# WENONA PROJECT ARCHIMEDES

WENONA SCHOOL PTY LTD

## MARK-UP OF SECTION 96 INCLUSIONS

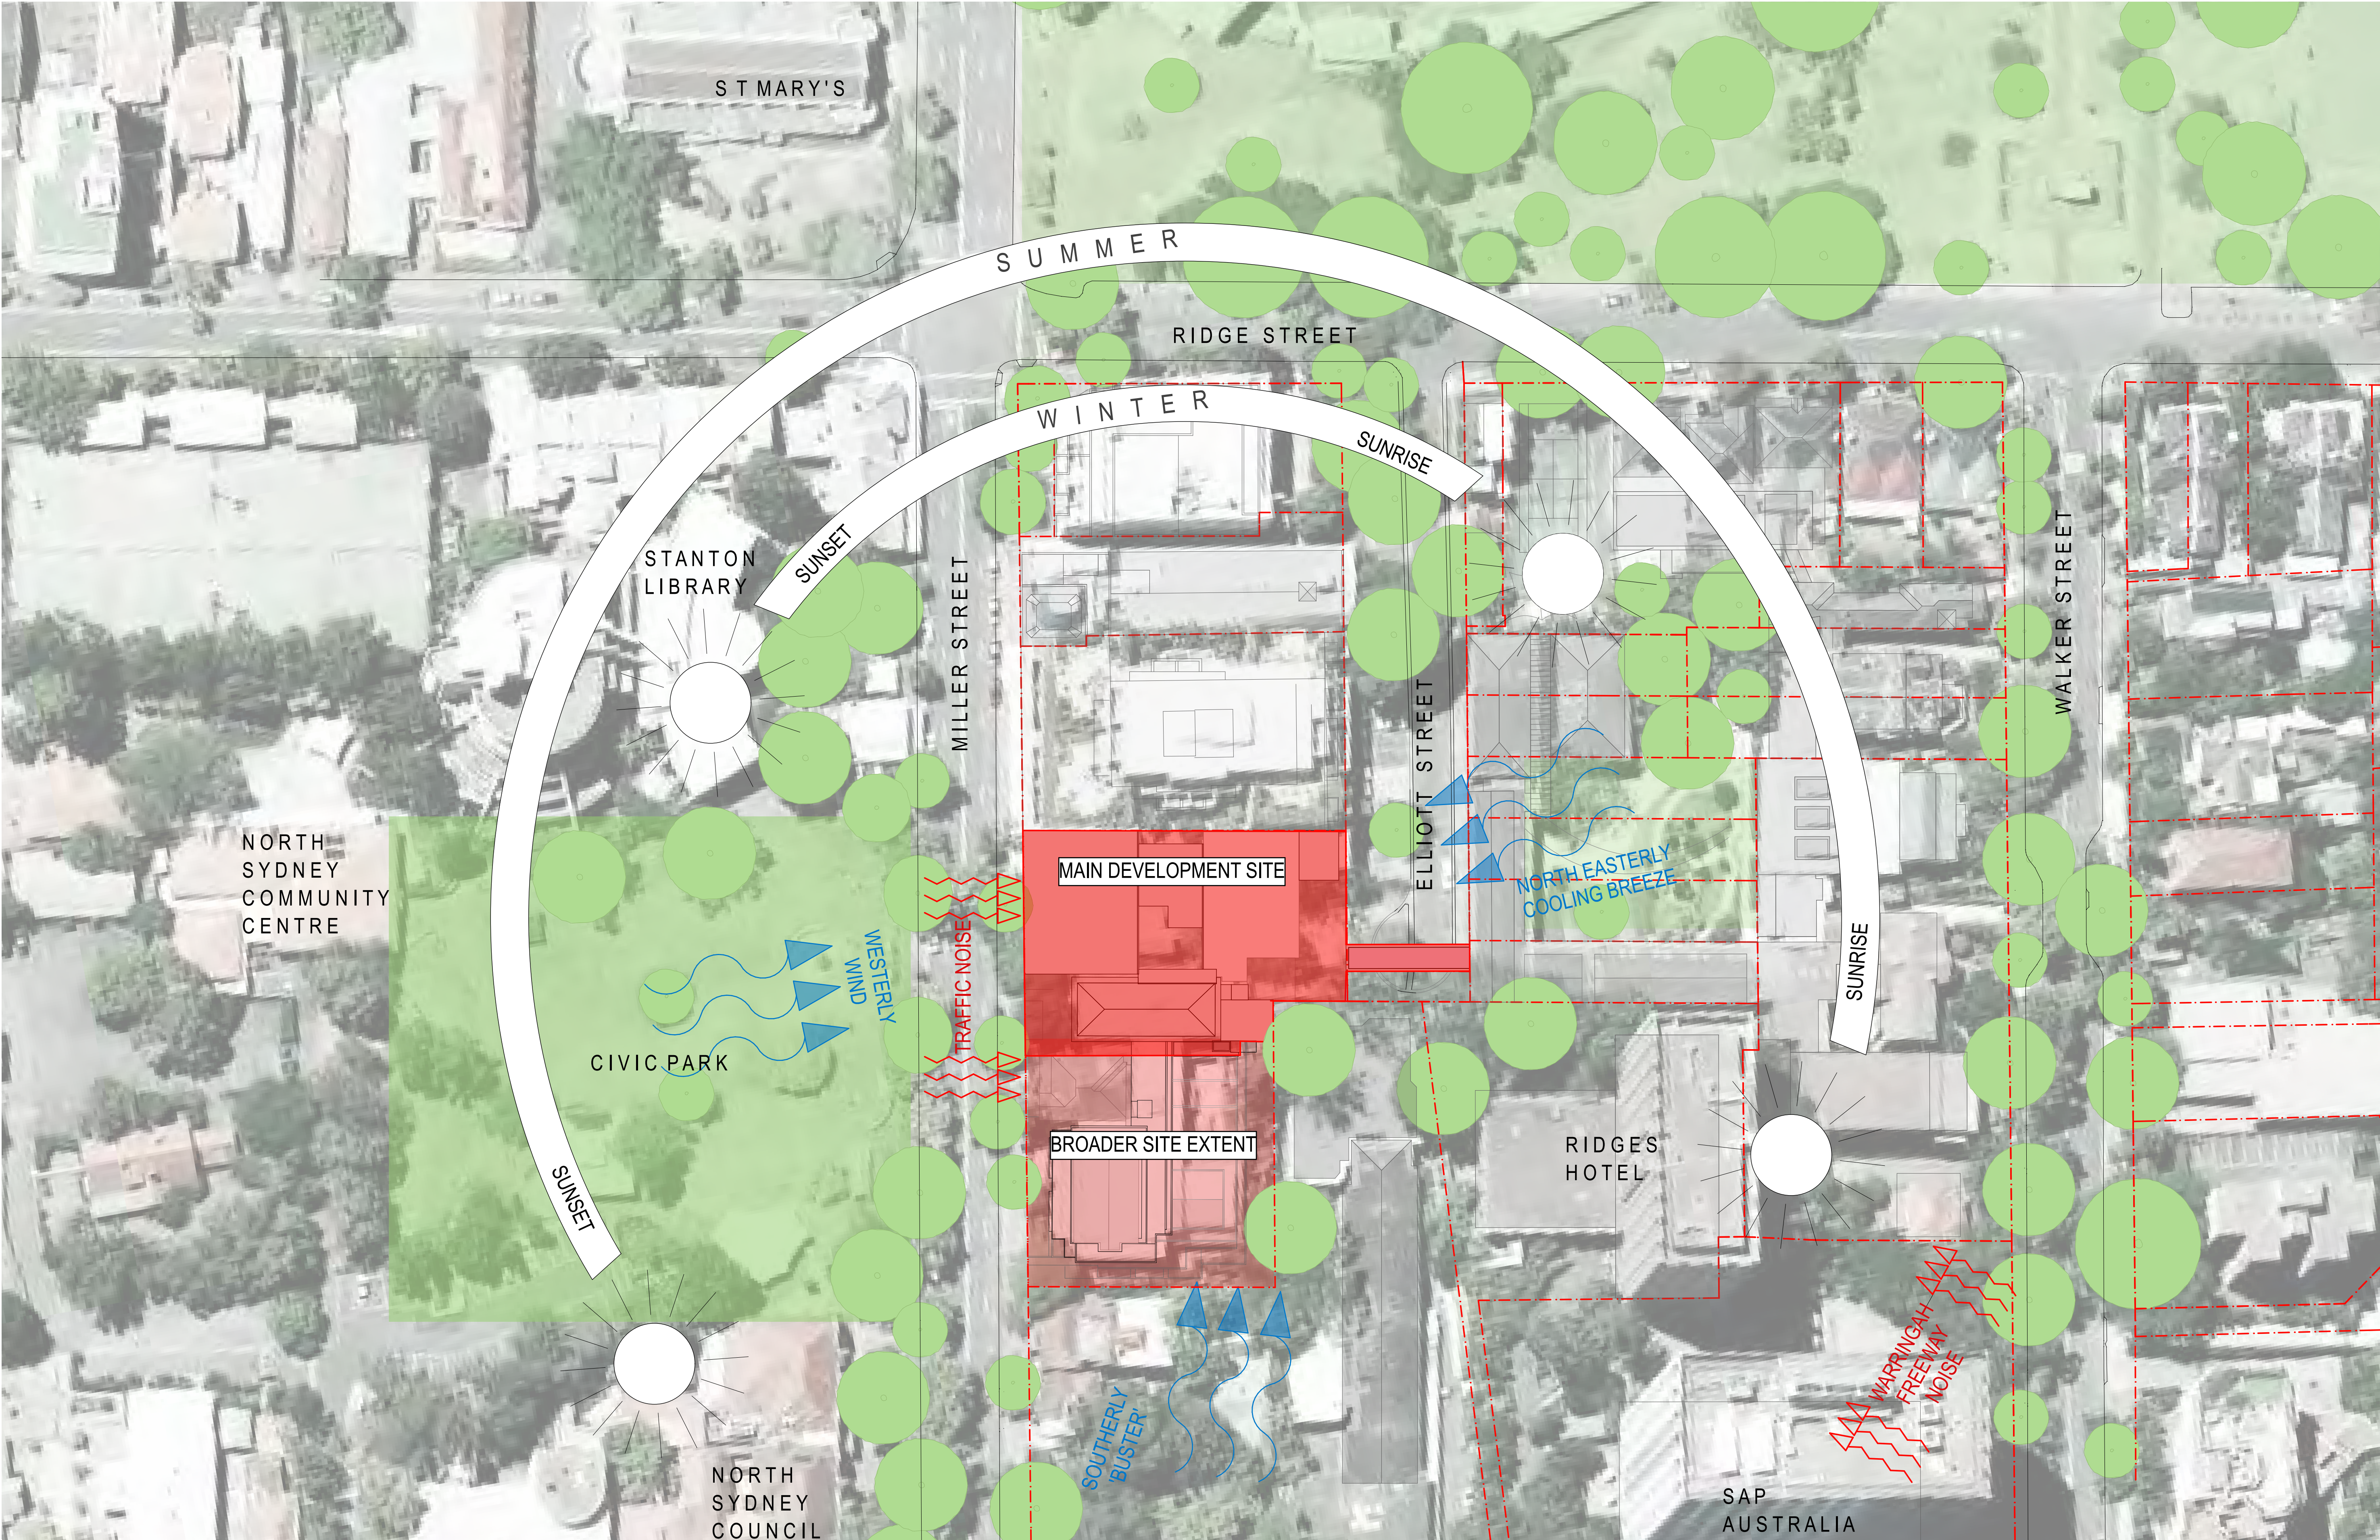
Items requiring S96 approval highlighted below;

**21** Addition of Metal Cladding to the Materials.

Legend updates other;

-Rain Water Tank

-Grease Arrestor

-Metal Roof Gutter

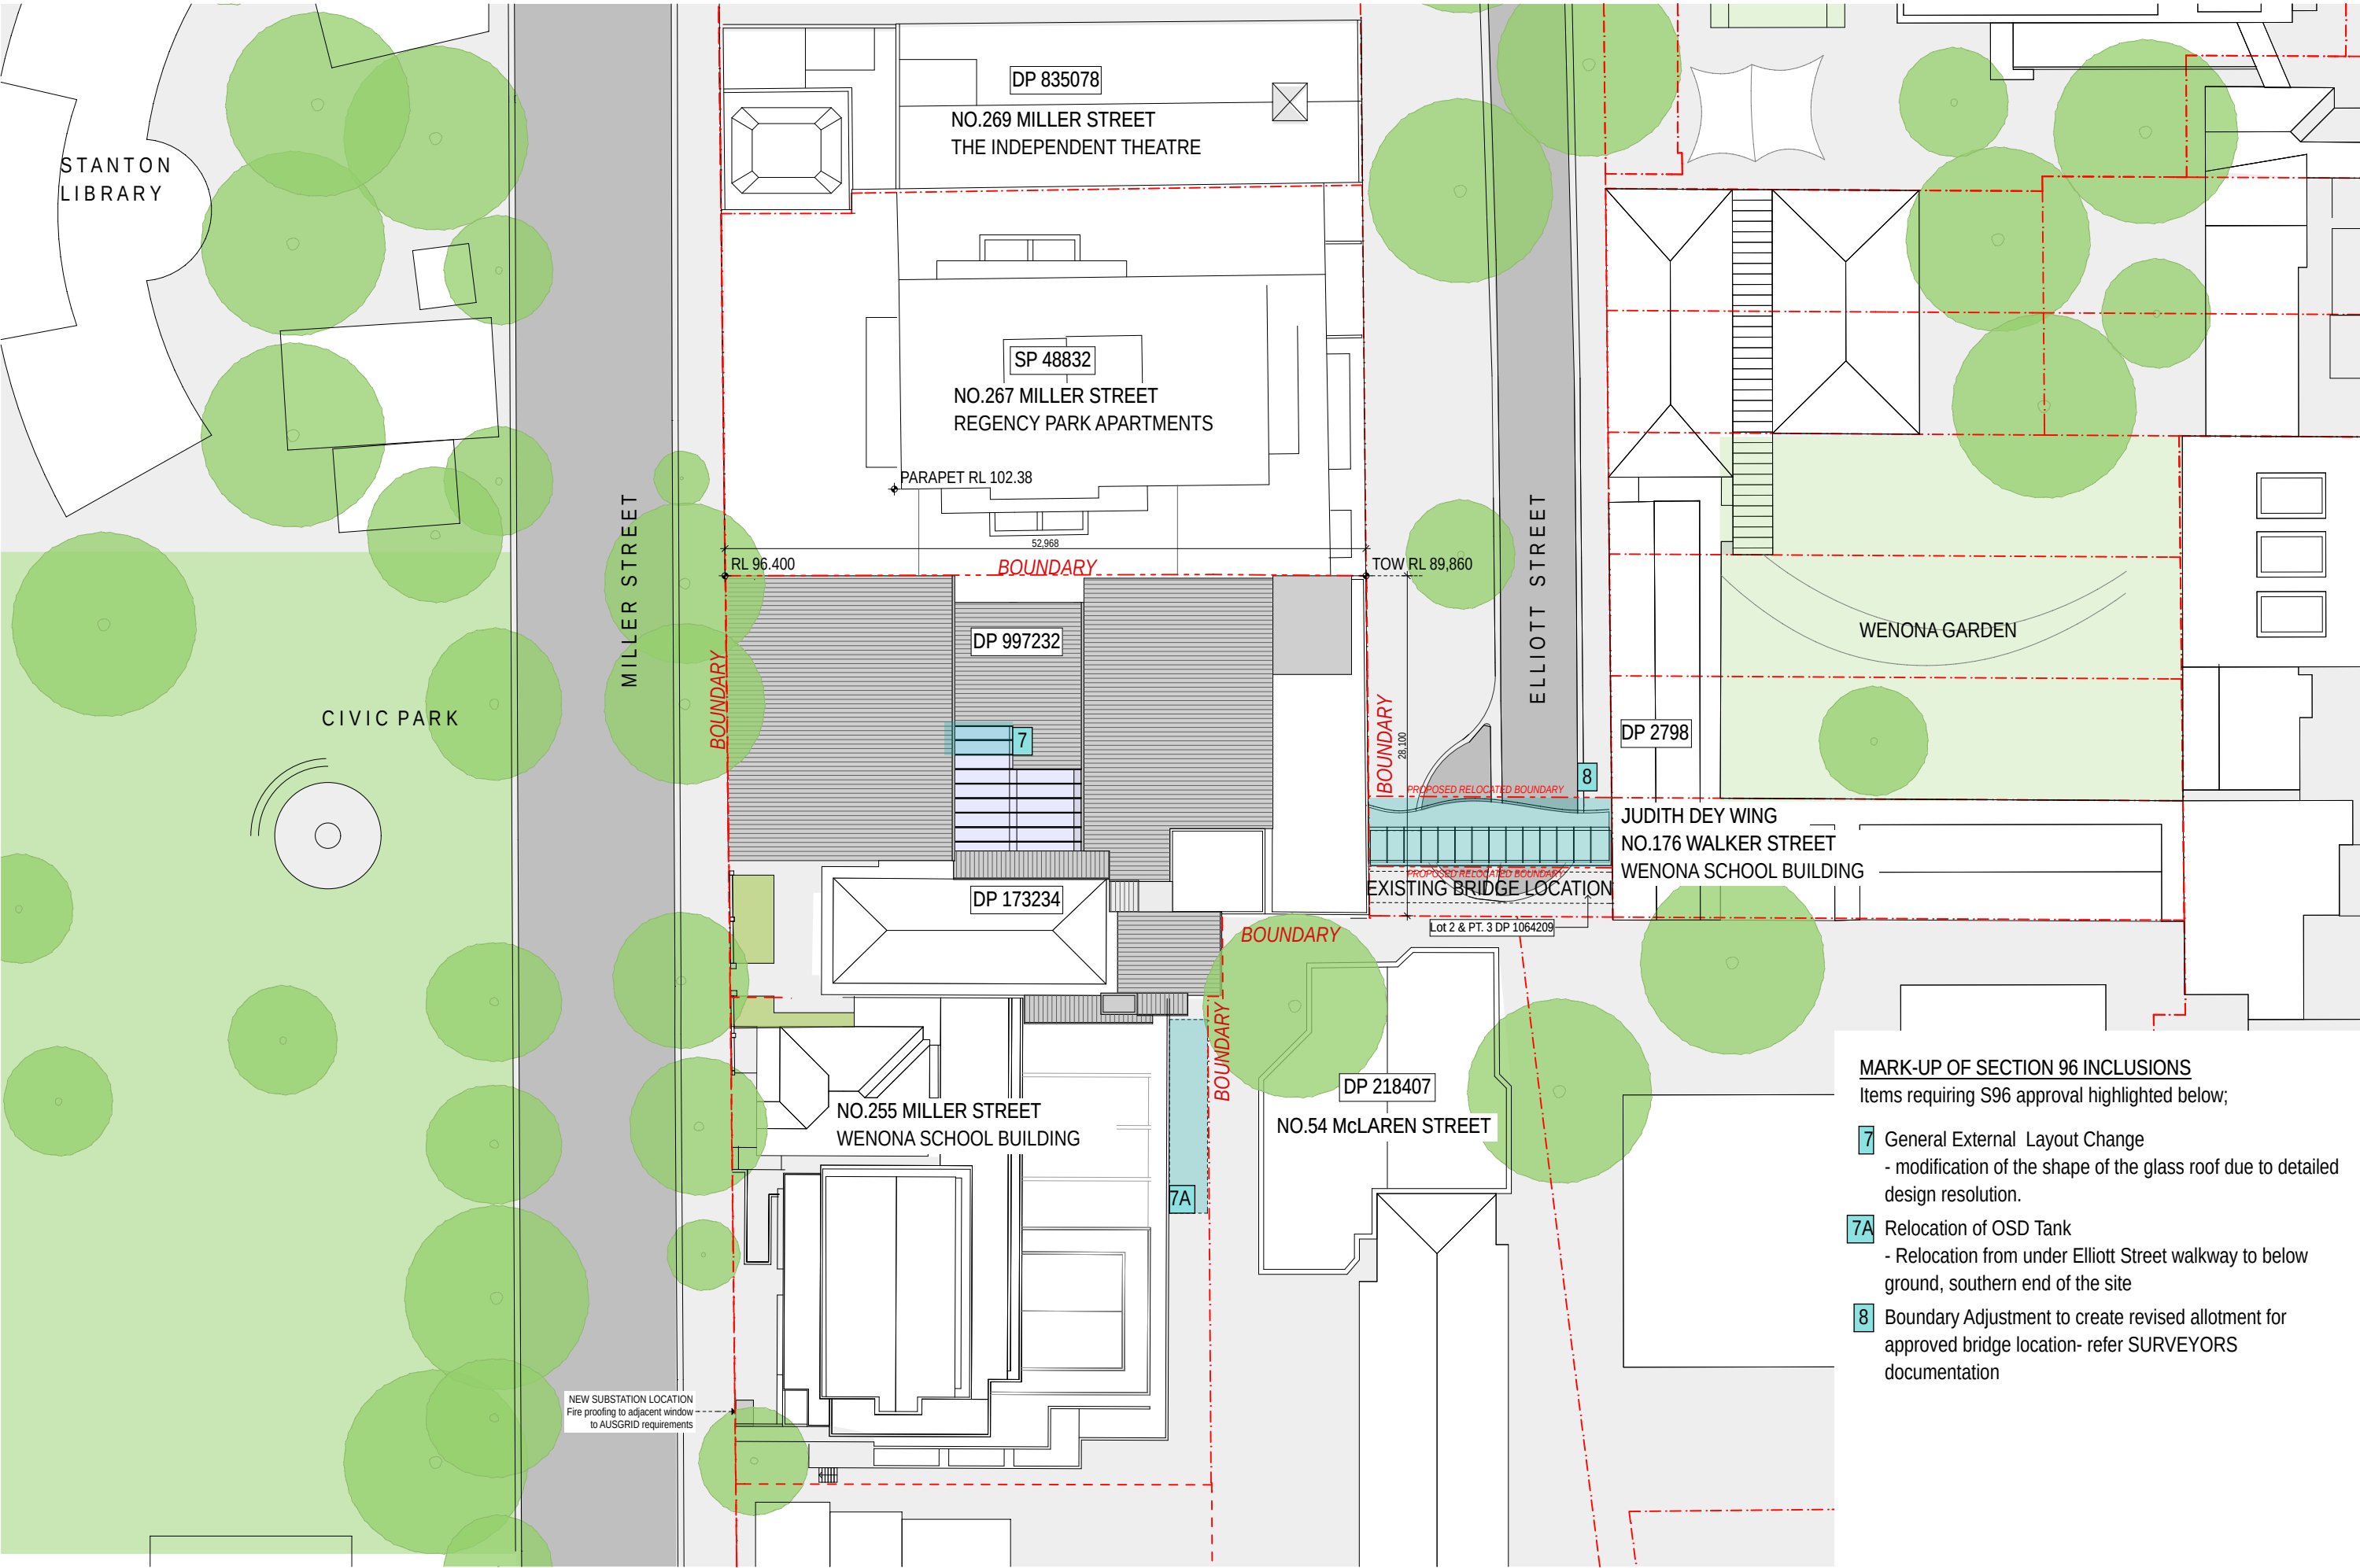
**MARK-UP OF SECTION 96 INCLUSIONS**  
Items requiring S96 approval highlighted below;

- 7** General External Layout Change  
- modification of the shape of the glass roof due to detailed design resolution.
- 7A** Relocation of OSD Tank  
- Relocation from under Elliott Street walkway to below ground, southern end of the site
- 8** Boundary Adjustment to create revised allotment for approved bridge location- refer SURVEYORS documentation
